**NEW MEXICO
ENVIRONMENT DEPARTMENT**

**RE: RESPONSE TO COMMENTS JANUARY 29, 2020 APPROVAL WITH MODIFICATIONS,
RESPONSE TO APPROVAL WITH MODIFICATIONS 2017 ANNUAL GROUNDWATER
MONITORING REPORT
WESTERN REFINING SOUTHWEST INC., GALLUP REFINERY
EPA ID # NMD000333211
HWB-WRG-18-014**

RE: Second Response to Approval with Modifications
2017 Annual Groundwater Monitoring Report
Marathon Petroleum Company LP, Gallup Refinery
(dba Western Refining Southwest, Inc.)
EPA ID# NMD000333211
HWB-WRG-18-014

RESPONSE TO COMMENTS
January 29, 2020 Approval with Modifications, Response to Approval with Modifications 2017
Annual Groundwater Monitoring Report Gallup Refinery
(June 2019)

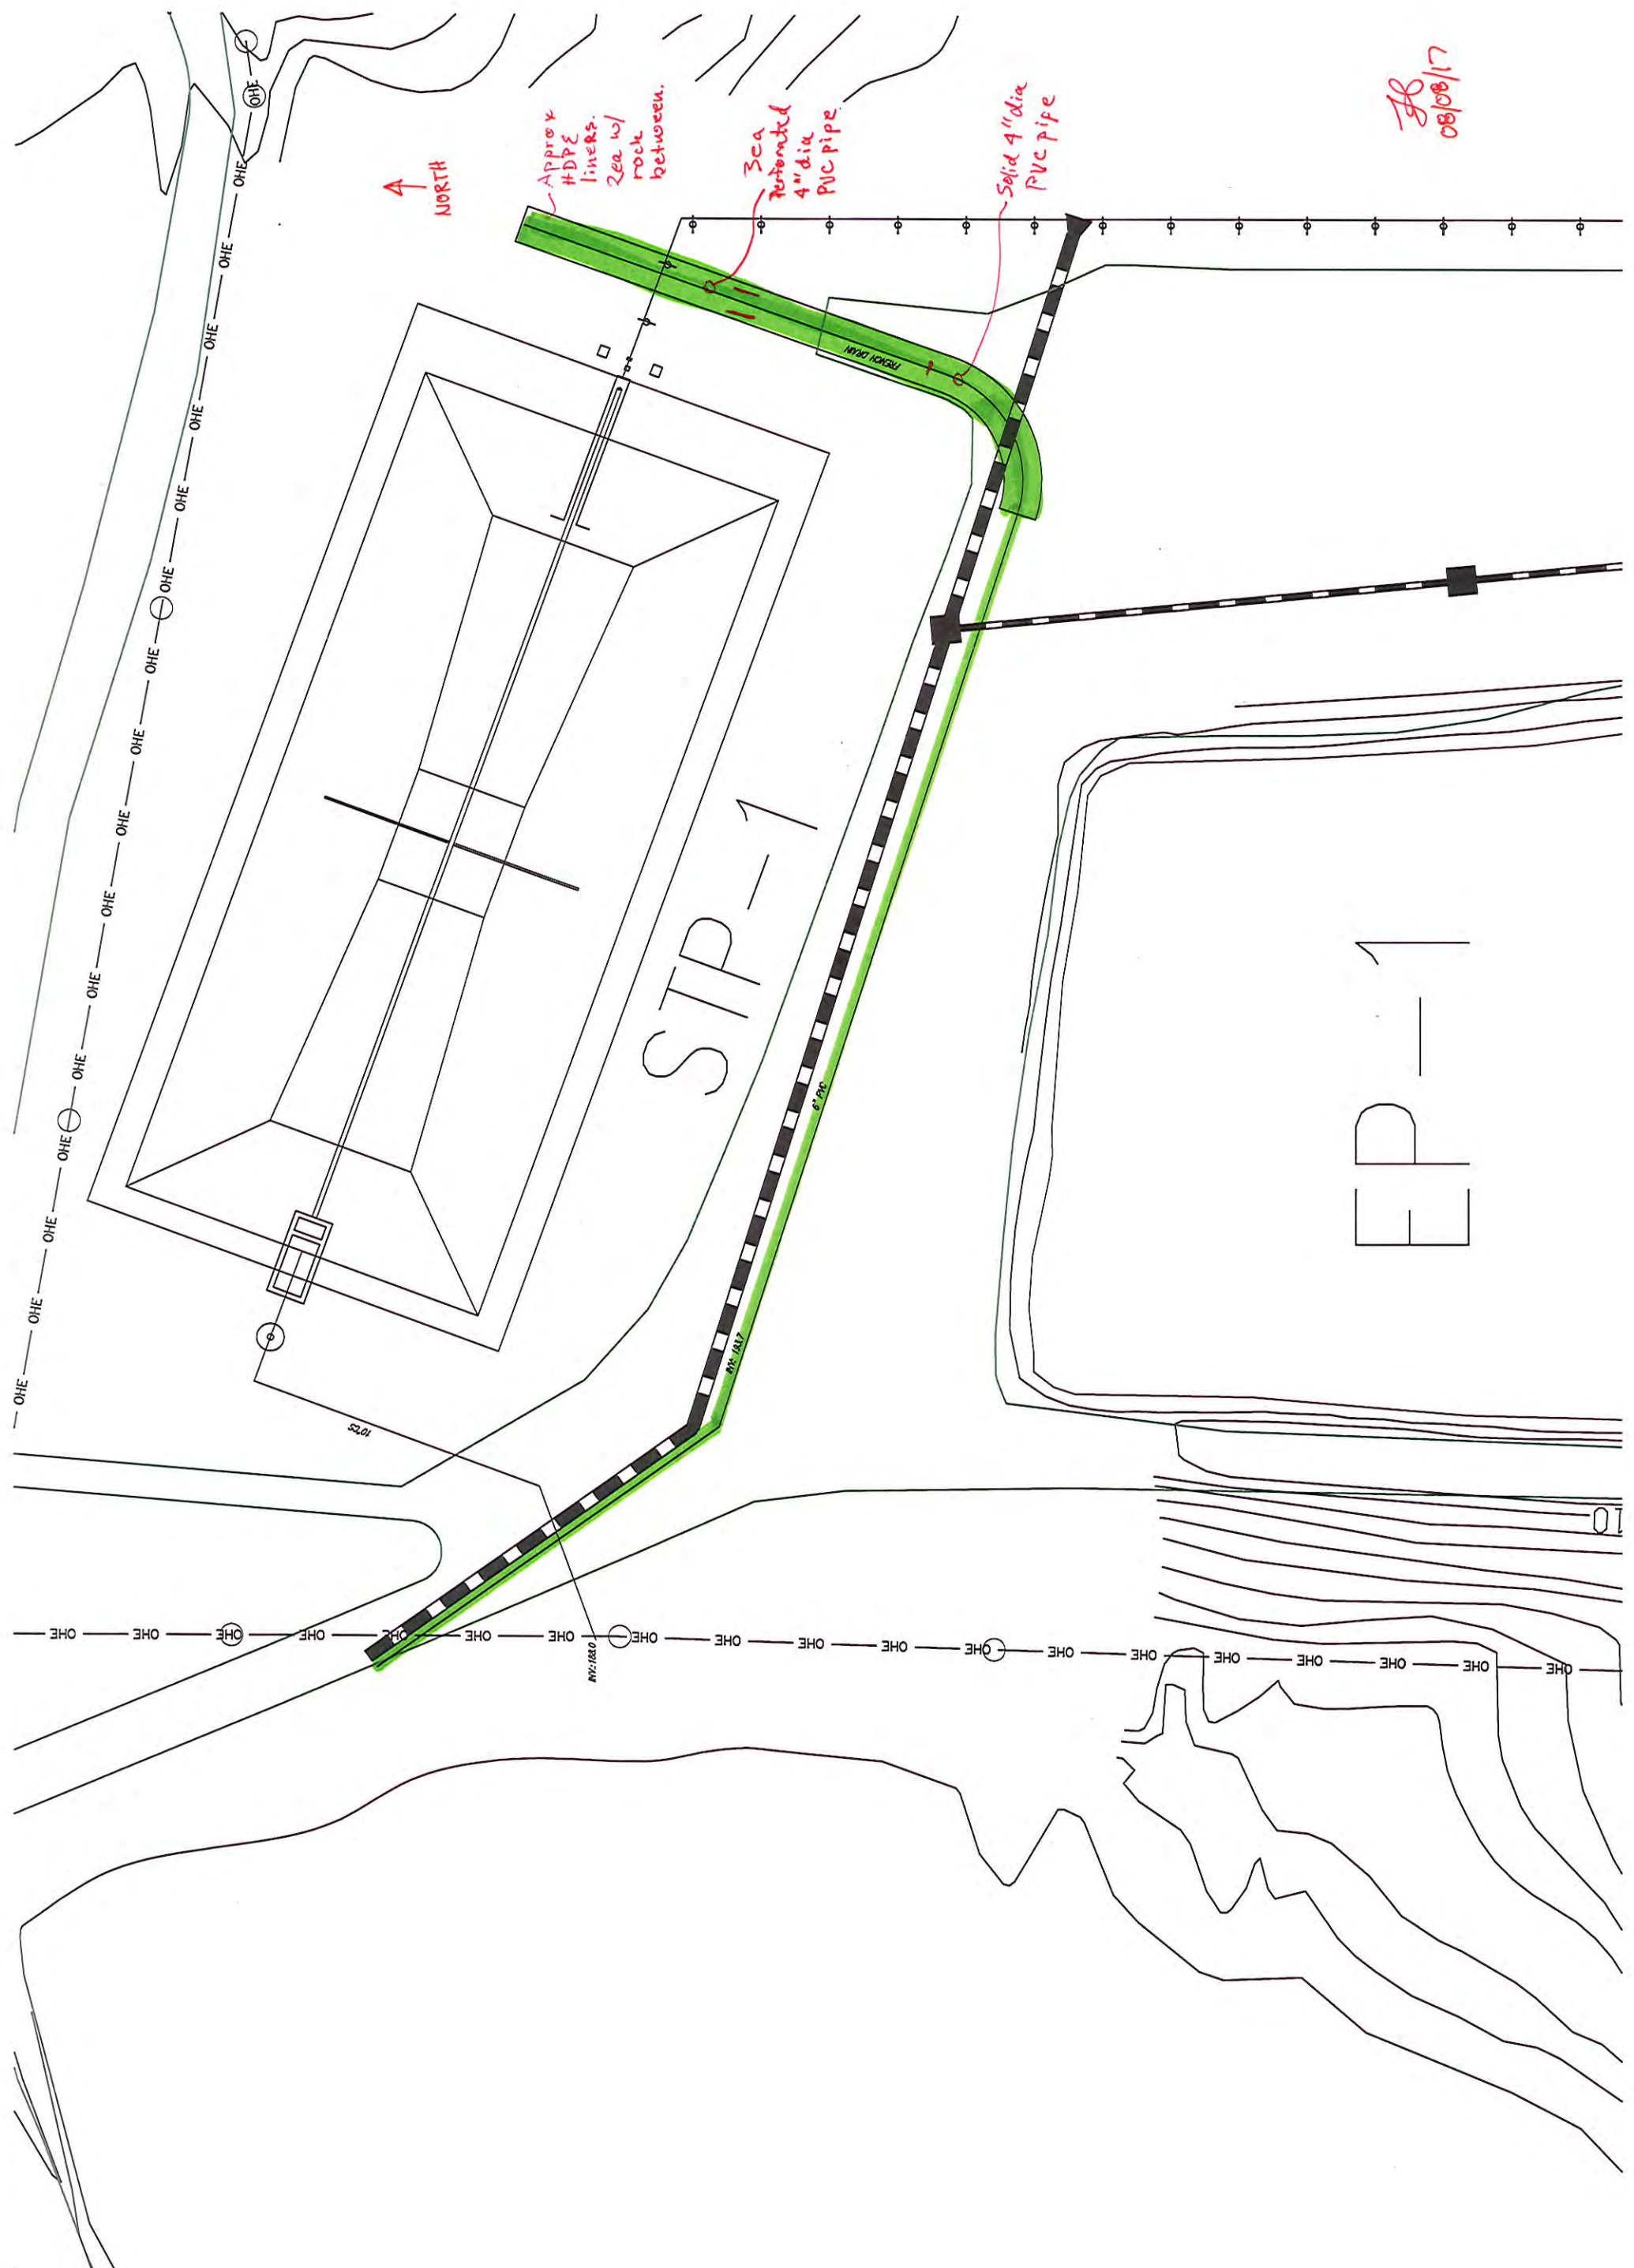
The Permittee's response to NMED's Comment 1 states, "[t]he discharge of hydrocarbon from the drain line to the STP-1 French drain was discovered on February 6, 2018." Four figures are included in the Response; however, three of the figures do not have titles. On the first figure, the location of the STP-1 French drain is identified; however, the location of the drain line is not identified. Identify the location of the drain line in relation to the location of the STP-1 French drain in a revised figure.

The figure depicting the excavations highlighted excavations #9 and #10 in red and the rest of the excavations in green. Explain the basis for distinguishing the color of these excavations in the response letter.

The third paragraph on page 2 of the Permittee's response to NMED's Comment 1 states, "[i]n addition to the excavations completed using either a backhoe or hydroexcavation, smaller holes were hand excavated to the east of STP-1 along the natural drainage pathway, where hydrocarbons were encountered at shallow depths (e.g., 3 feet). Hand excavations were also completed on the northwest sides of Tanks 569, 570, 571, and 572, but no evidence of a release was found." The locations of the small excavations were not identified in the figures, revise a figure to depict the locations of the small excavations and indicate the presence or absence of hydrocarbons.

Enclosed you will find a figure showing the location of the French drain on the east side of STP-1 and the drain line, which drains the water that accumulates in the French drain as well as storm water collected in the area of the wastewater treatment plant.

The storm drains were checked and as noted in response #5 above we have been able to confirm that the use of the color purple on the map indicates the presence of hydrocarbon. Apparently, at the time the map was prepared hydrocarbons were not found to be present in the storm drains.

The hand excavations were completed in a random manner as a quick check to see if hydrocarbon could be identified at shallow depths along the drainage pathway east of STP-1 and as such, the locations were not recorded. The general area of the hand excavations is shown on the enclosed figure. Similarly, the locations of the hand excavations near the listed tanks were not recorded, but their general locations are shown on the enclosed figure.
